Omaha Public Power District
Fort Calhoun Station-Unit No. 1

JUSTIFICATION, DISCUSSION, AND
SIGNIFICANT HAZARDS CONSIDERATIONS
FOR CYCLE 10 RELOAD

Fort Calhoun
Cycle 10
License Application

Figure
1-1

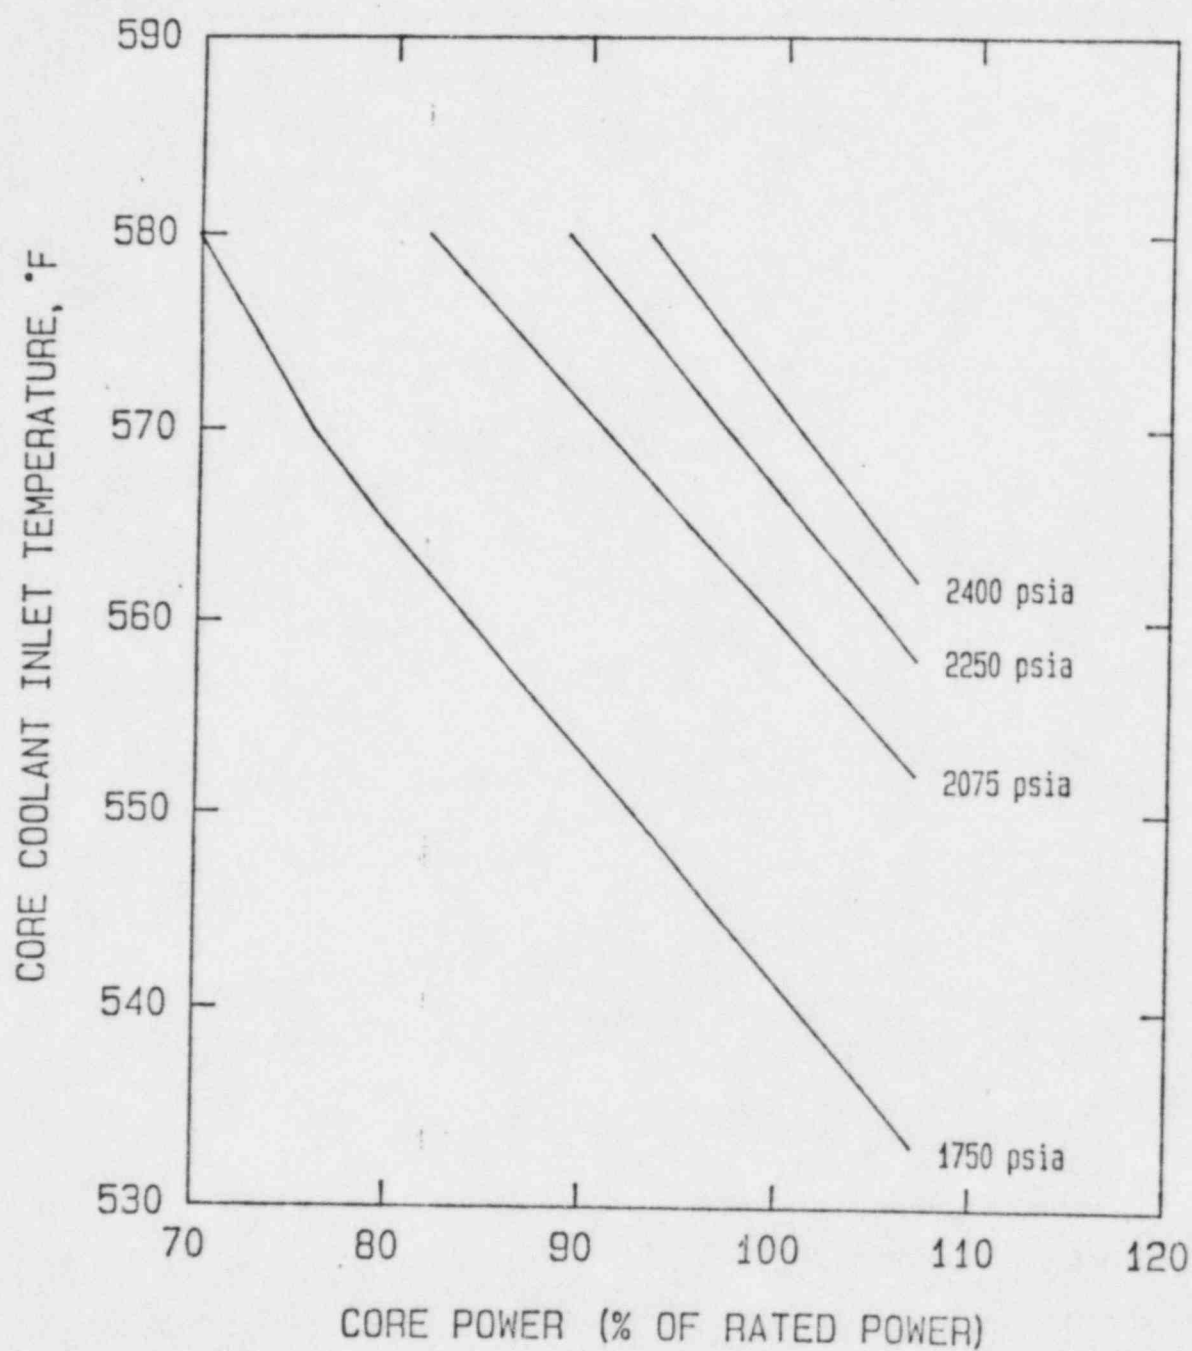
4. Figure 1-1	Replace Figure 1-1 with enclosed Figure 1-1.	The TM/LP safety limits have been changed to reflect changes in peaking factors and inclusion of ASI input into the TM/LP cal- culators.

The curves of Figure 1-1 represent the loci of points of reactor thermal power (either neutron flux instruments or ΔT instruments), reactor coolant system pressure, and cold leg temperature for which the DNBR is 1.18. The area of safe operation is below these lines.

Figure
1-3

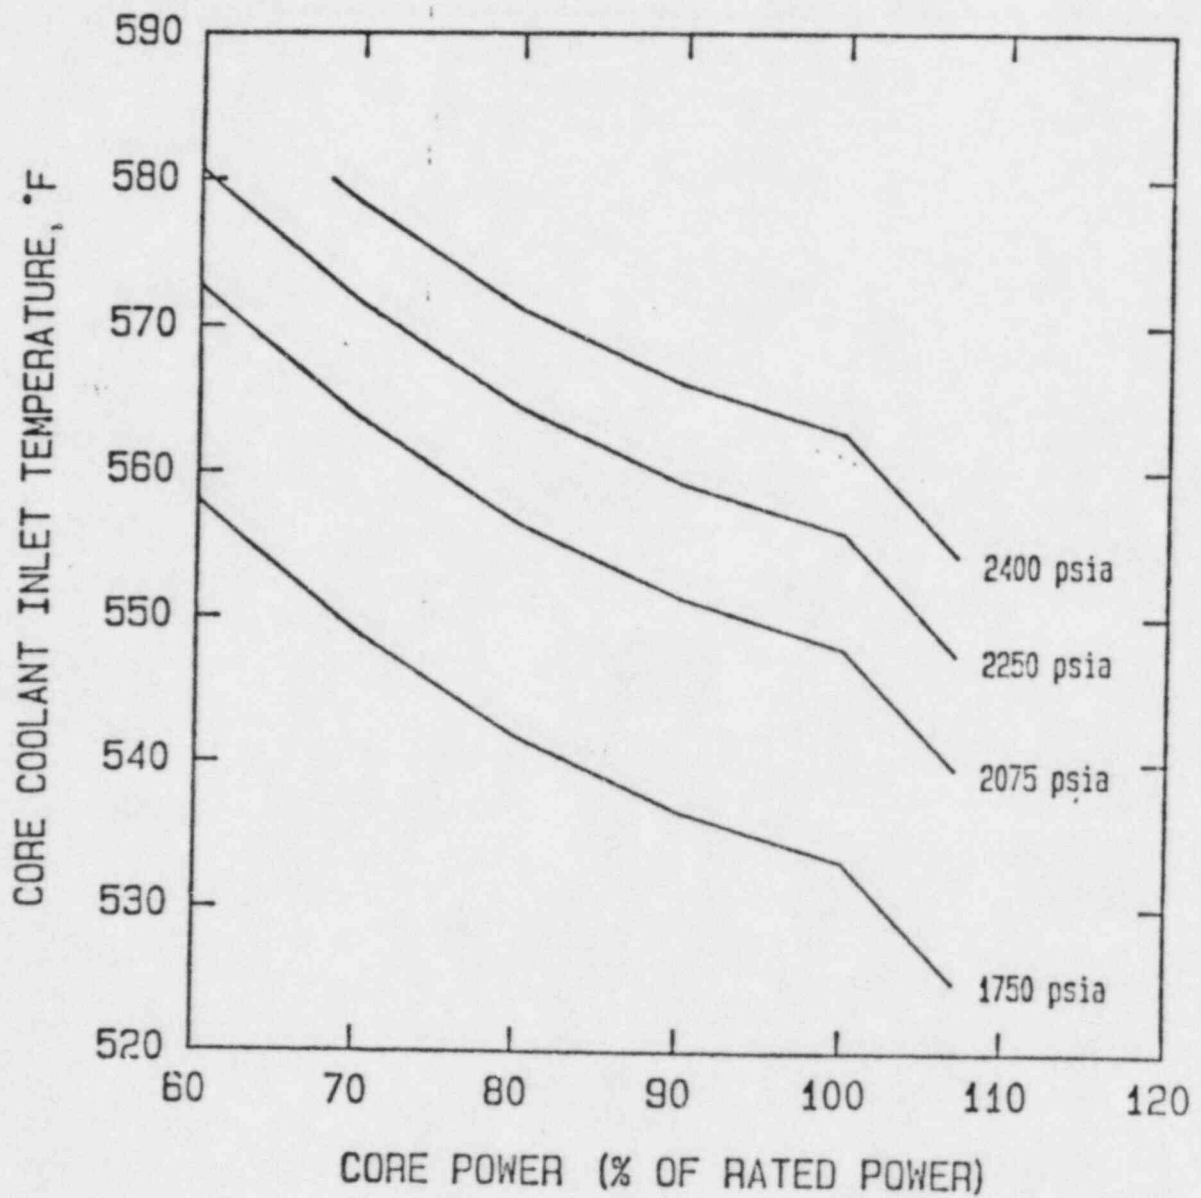
5. Figure 1-3	Replace Figure 1-3 with enclosed Figure 1-3.	The TM/LP trip LSSS equation has been adjusted to reflect ASI in- put into the TM/LP calculators. (Item 11, Reload Evaluation).

$$P_{VAR} = 22 \text{ PF (B) } A1 (Y) B + 22.1 T_{IN} - 12674$$

$$\begin{aligned} \text{PF (B)} &= 1.0 \quad B \geq 100\% \\ &= -.008 B + 1.8 \quad 50\% < B < 100\% \\ &= 1.4 \quad B \leq 50\% \end{aligned}$$

$$\begin{aligned} A1 (Y) &= -.5 Y_I + 1.125 \quad Y_I \leq .25 \\ &= .5 Y_I + .875 \quad Y_I > .25 \end{aligned}$$

Figure
2-6

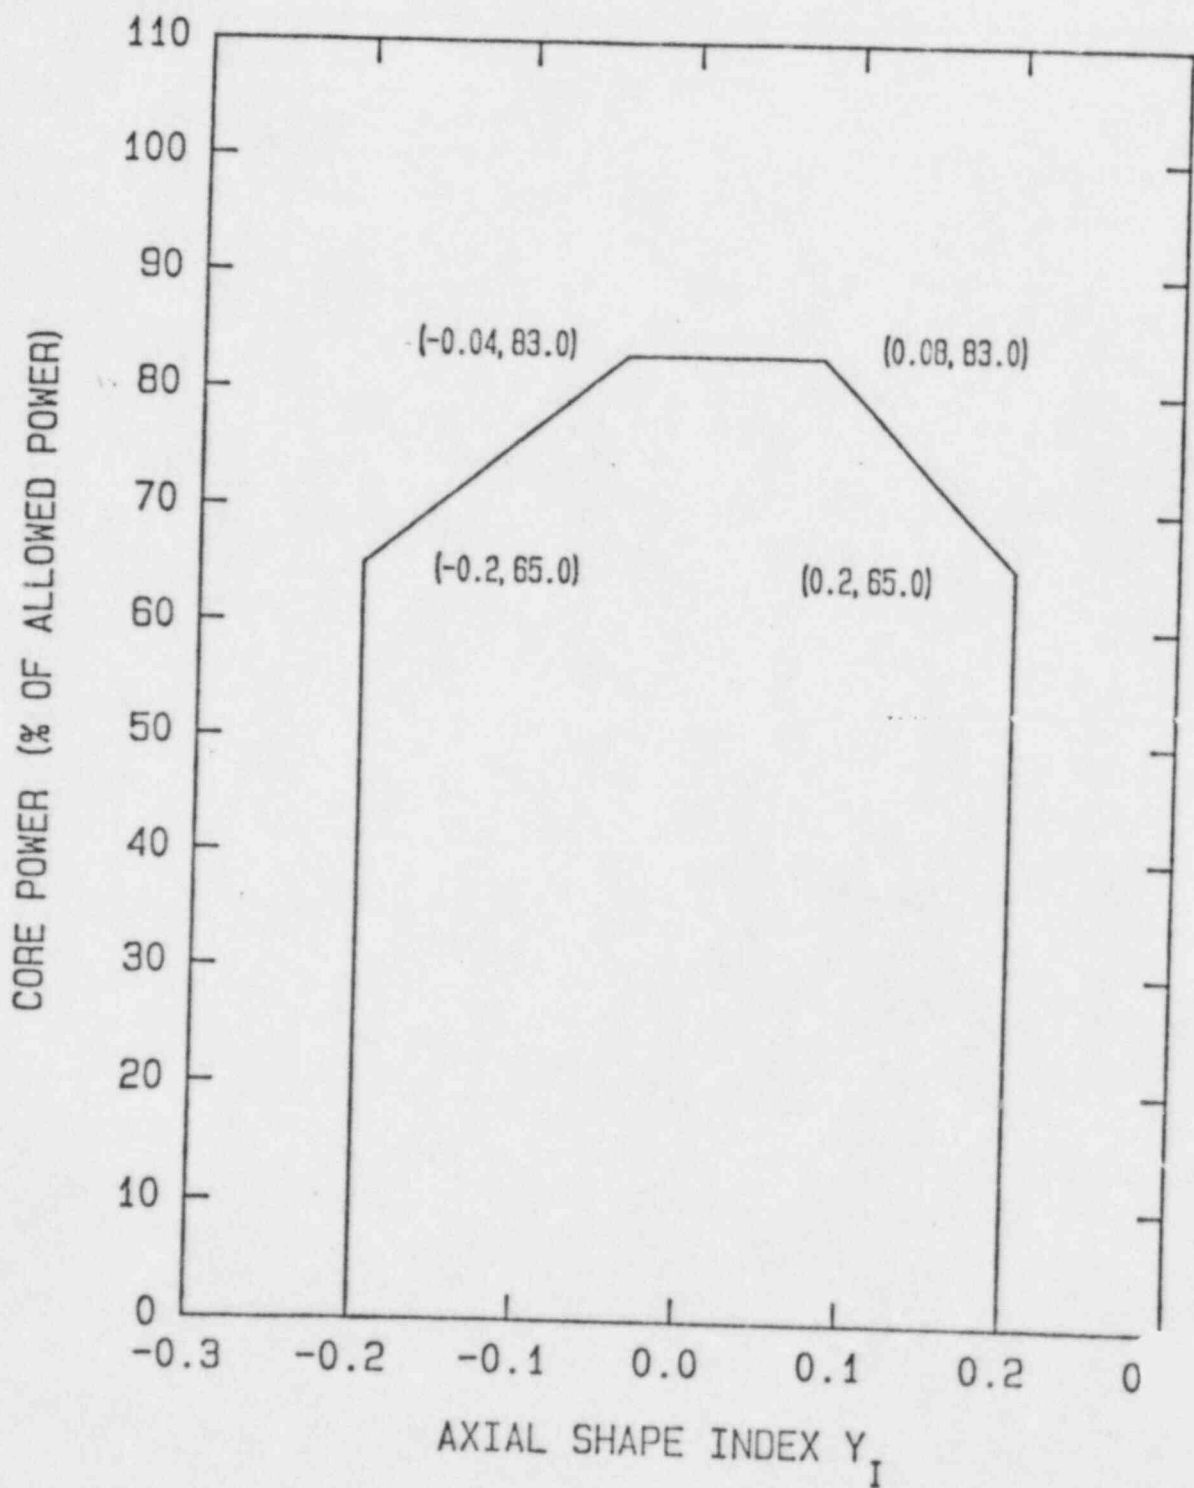
8. Table 1-1 No. 1 and 2 Pg. 1-10	Delete references to 3- and 2- Pump Oper- ation.	The Fort Calhoun License is lim- ited to 4-Pump operation.
9. Figure 2-6	Replace Figure 2-6 with Enclosed Figure 2-6.	The LHR excore LCO has been changed to reflect higher radial peaking factors.

Figure
2-9

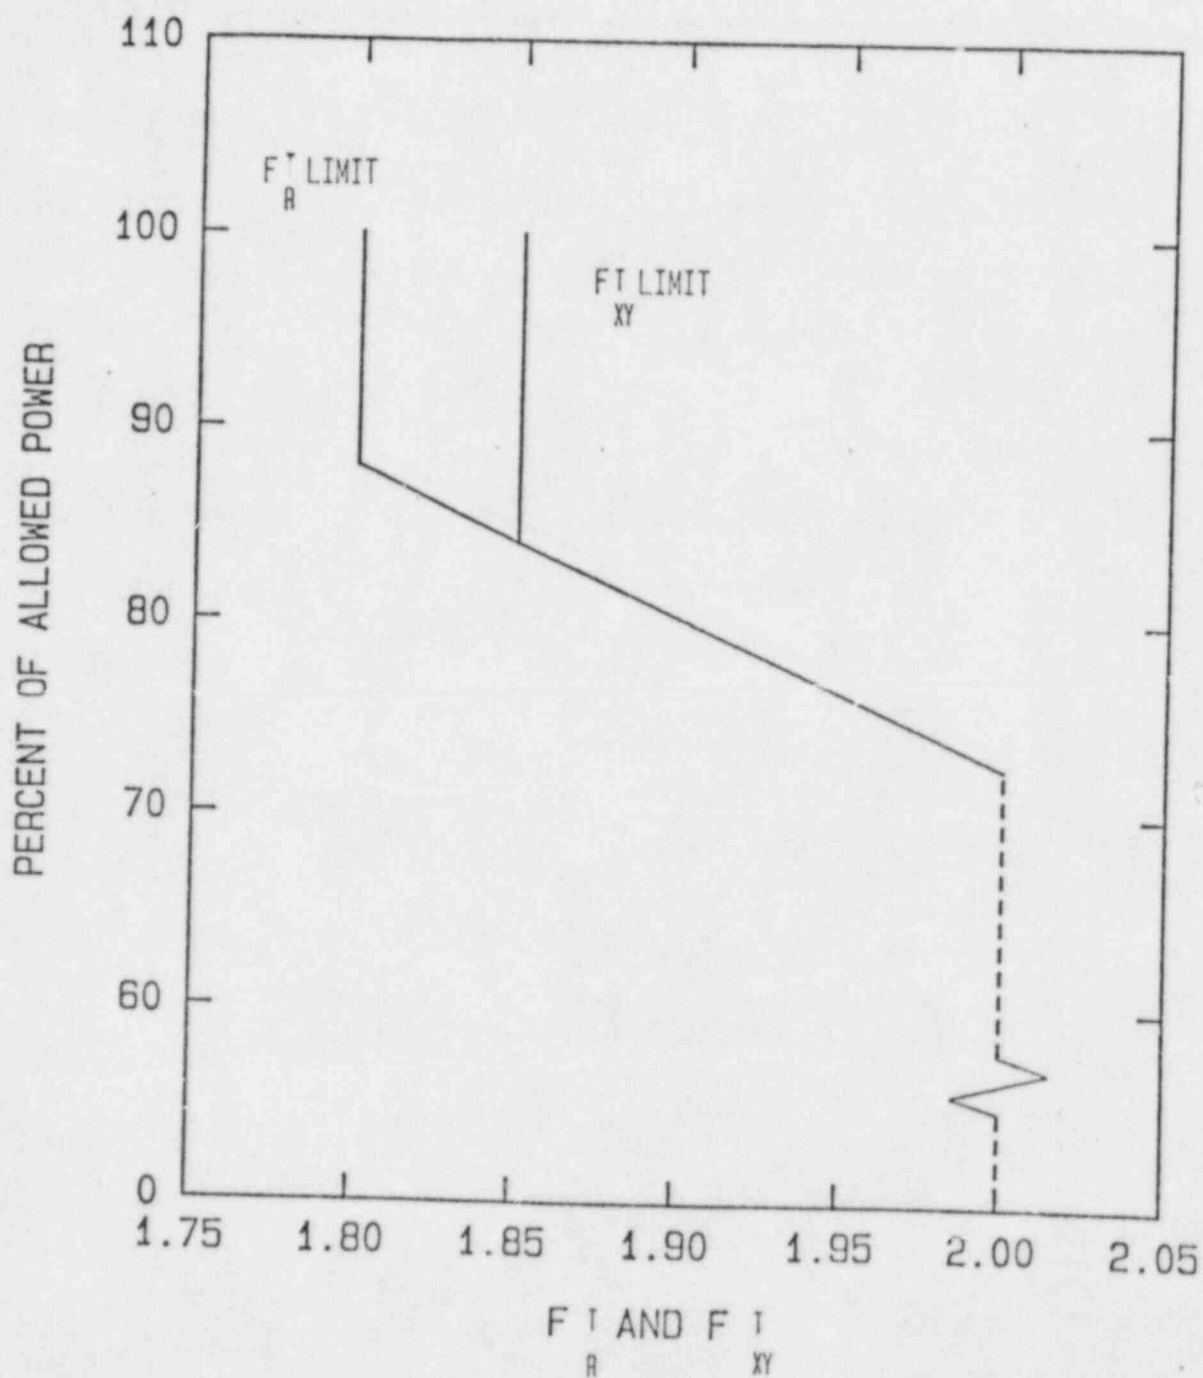
10. Figure 2-9	Replace Figure 2-9 with enclosed Figure 2-9.	The F_{xyT} and F_{RT} limits have been changed to reflect higher peaking factors. The asymmetric loading pattern impacted the shape of the F_{xyT} limit line.

FIGURE 11-1

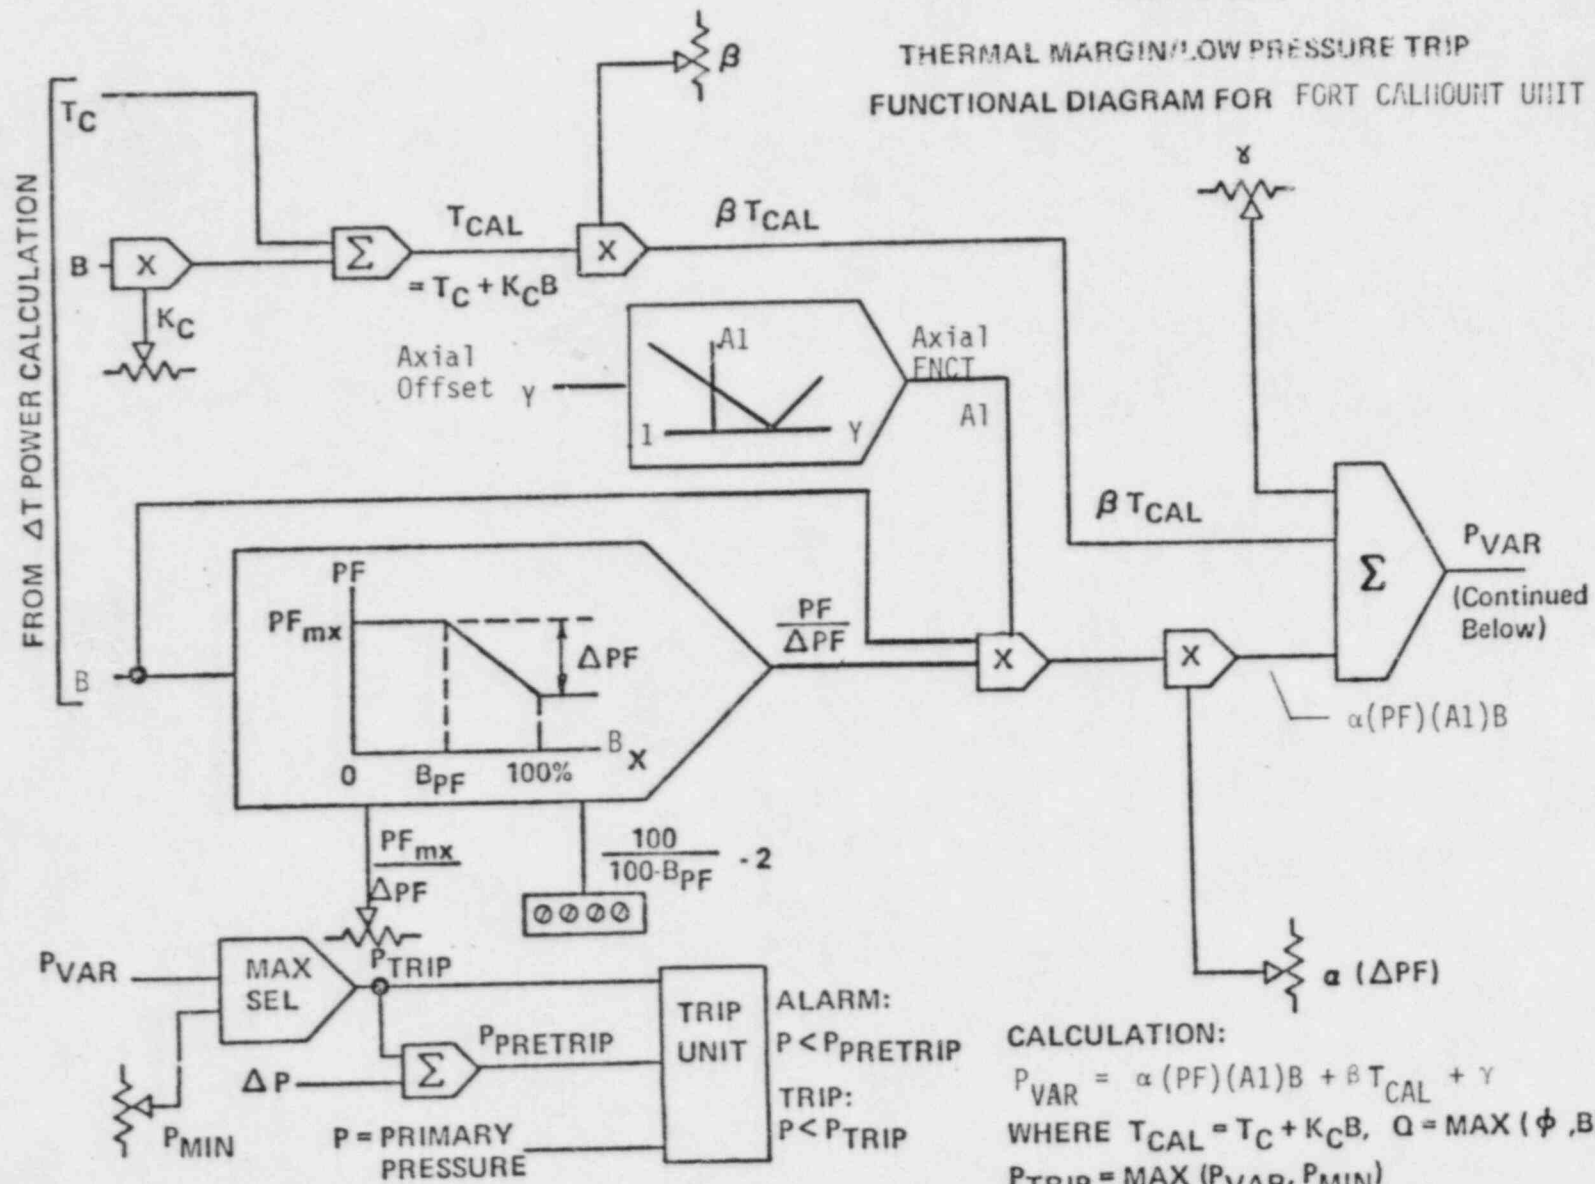
Figure 11-1 is a simplified functional diagram of this system. The signal representing the core power (B) is the auctioneered highest of the neutron heat flux and the delta-T power. This signal is used to calculate the PF function. The PF term multiplied by the core power is the equivalent to the QR1 term in the "standard" TM/LP equation. The measured axial shape index signal (Y), which includes the adjustment for shape annealing and represents the peripheral axial shape index, is used to calculate A1. The A1, PF, B, and the constant α are multiplied together to generate a signal representing the first term in the PVAR equation.

The change to the TM/LP calculators was the addition of the A1 function. The balance of the system is unchanged.
